WEBSTER UNIVERSITY ISB	
PROJECT NAME	
8274 BIG BEND BLVD	
ADDRESS	
NUMBER	
WEBSTER UNIVERSITY	
OWNER	
CANNON DESIGN	
ARCHITECT / ENGINEER	
Joe Voypick	
SUBMITTED BY	
042000-013	
CONTRACTOR / CM SUBMITTAL NO.	CANNON DESIGN SUBMITTAL NO.
	042000
DRAWING / DETAIL REFERENCE	SPECIFICATION SECTION / PARAGRAPH
Leonard Masonry	
MANUFACTURER / SUPPLIER	ITEM / PRODUCT ID
REQUIRED DATE	PRIORITY
	CRITICAL

PROJECT: 15051-Webster University Interdisciplinary Science Building

SUBJECT: Submittal 945-01, Rev #0 Masonry materials

THE ORIGINAL **Pos-I-Tie®** BRICK VENEER ANCHORING SYSTEM

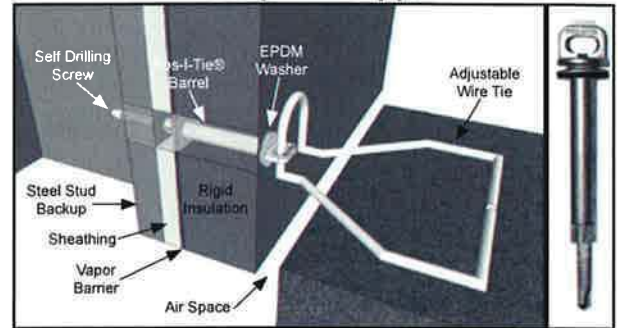
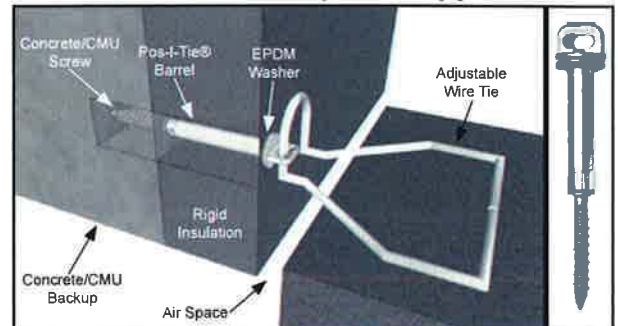
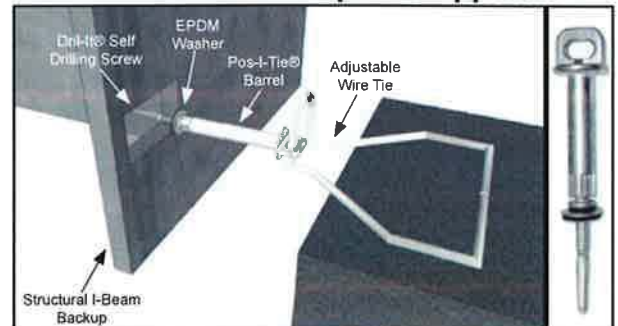
Designer verify this is acceptable
